23 May 2024
Addendum No 3
Columbus County 911 Center

The following addendum shall supersede previous information and does hereby become part of the contract documents.

BD-2

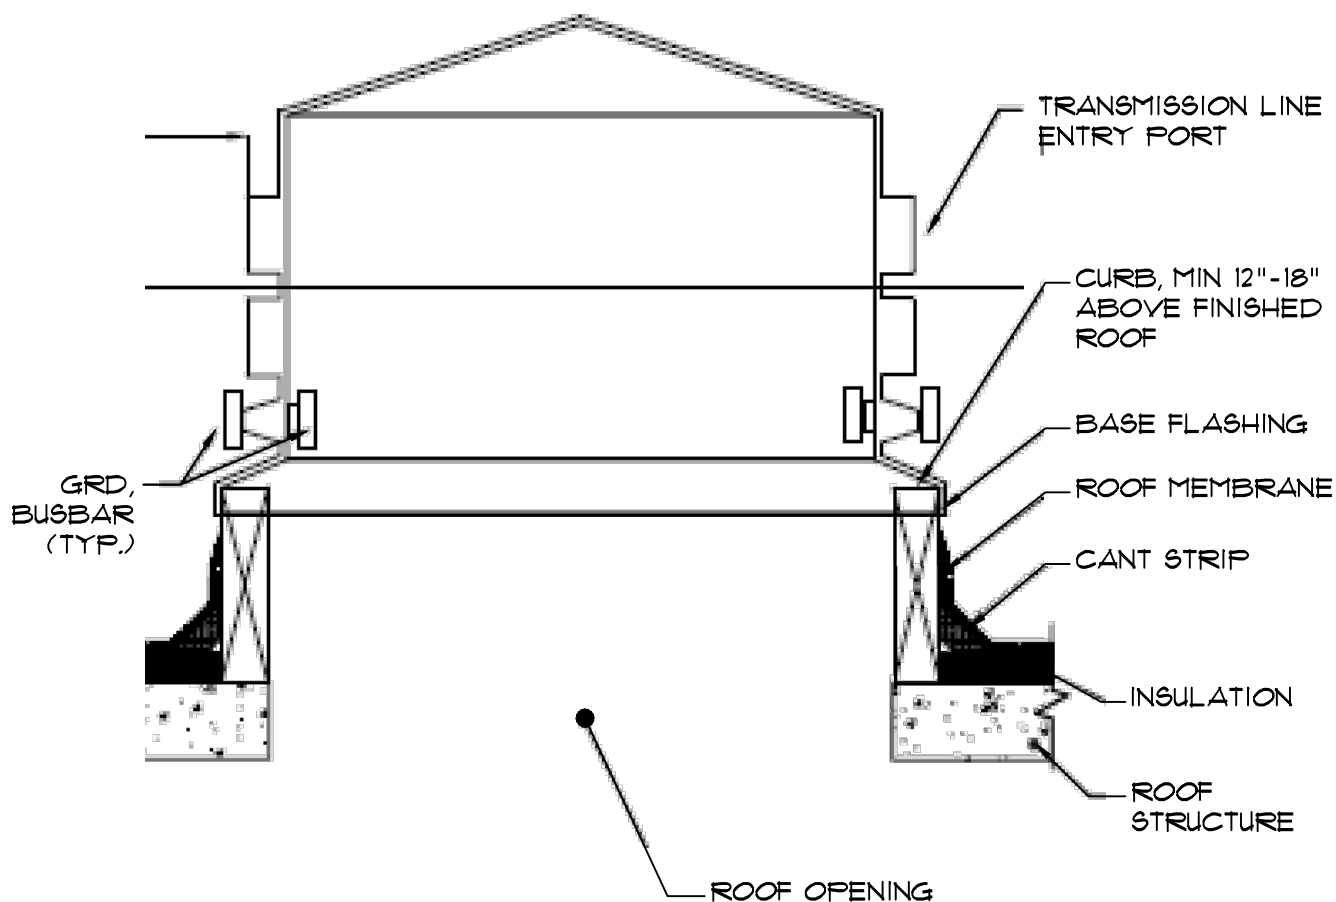
- See attached BD – 2 for typical installation of antenna portal with curb. Provide angles at all openings through roof. (similar to 6/S1.1)
- Drawings, P2: the electric water heater located in room 103 is to be located in Storage 114 to avoid extensive trenching. Electrical contractor shall also coordinate location of electrical wiring required for new location.

- ROOF MOUNTED ANTENNA PORTAL
- COORDINATE FINAL LOCATION WITH FIELD CONDITIONS
- PROVIDE SHOP DRAWINGS INDICATING SIZE OF OPENING AND ALL MATERIALS TO INSTALL THE TRANSMISSION LINE ENTRY PORT
- INSTALL THE CURB AND SEAL
- THE ROOFING MEMBRANE TO THE CURB AND THE ROOF MATERIALS COORDINATE WITH ROOFING SYSTEM PROVIDOR
